AMENDMENTS TO THE DRAWINGS

Applicant is submitting eleven replacement drawing sheets that include Figures 1-12.

FIG. 4

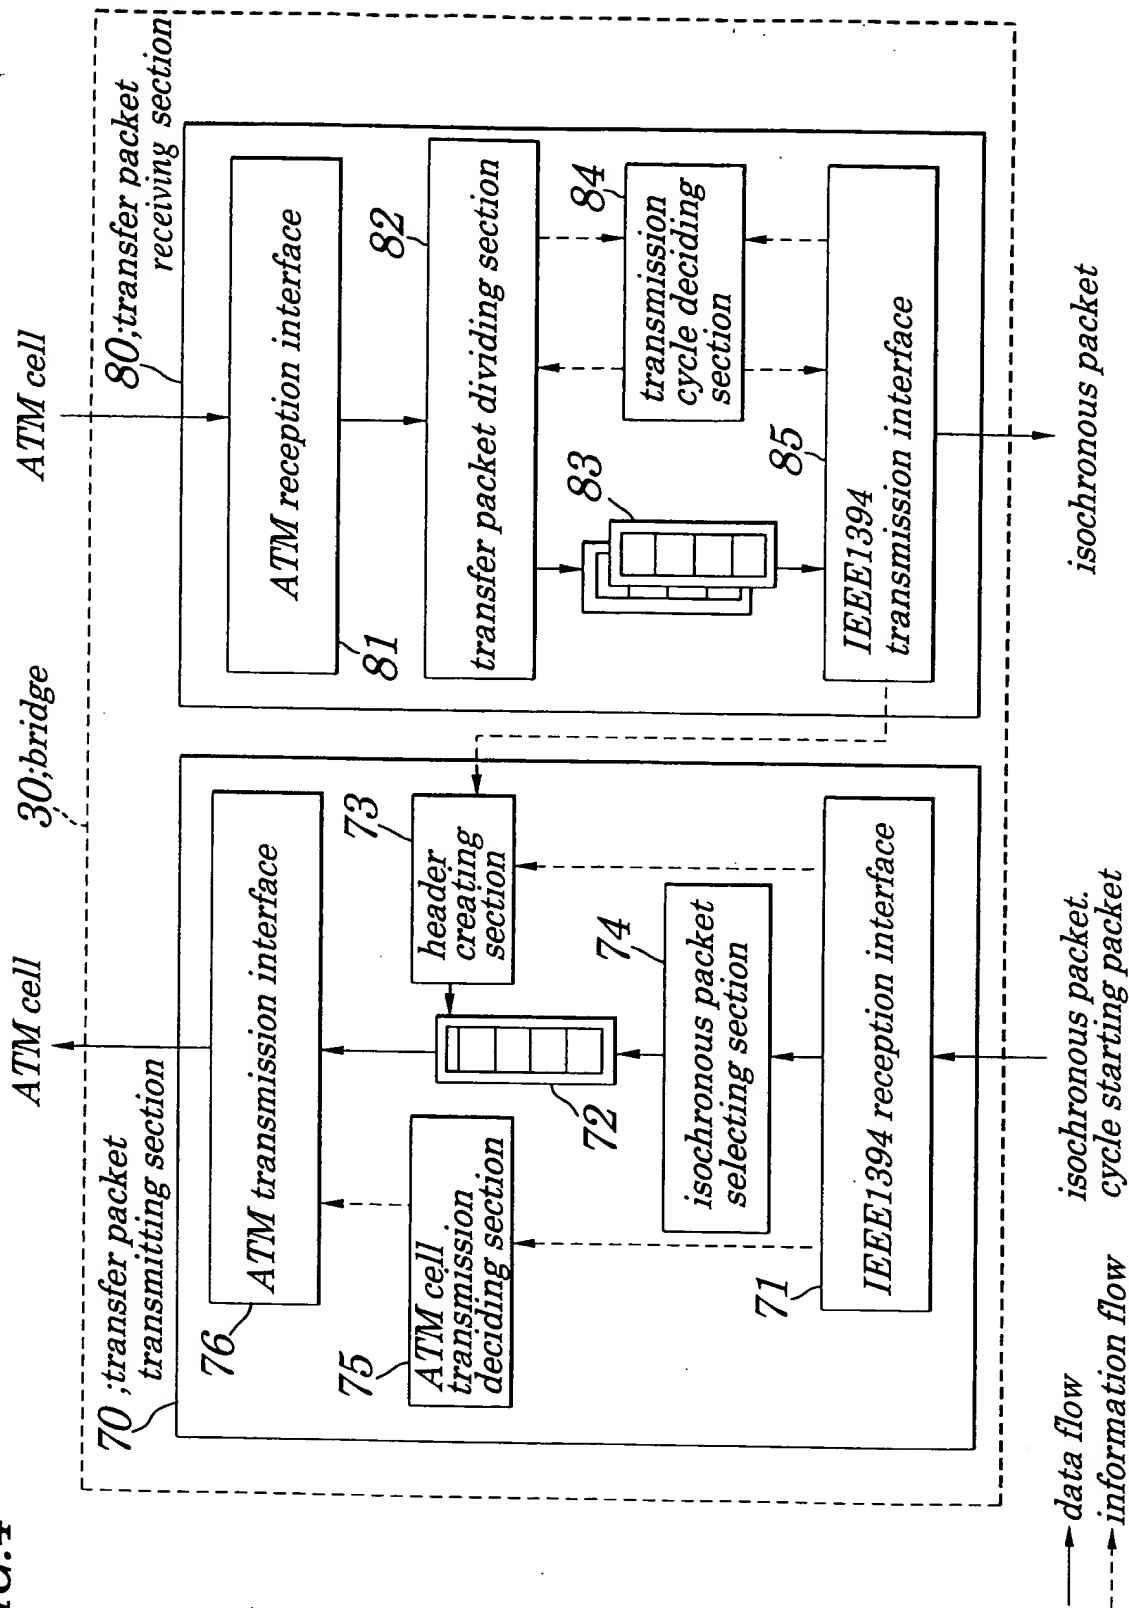
1. Figure 11. Step C1 now reads "create header" instead of "cleate header"
2. Figure 4. Element 80 now reads "receiving section" instead of "transmitting section."
3. Figure 8. Element 100 now reads "transmitting section" instead of "receiving section."
4. Figures 9 and 10. The label "VH" has been corrected to read "VPI."
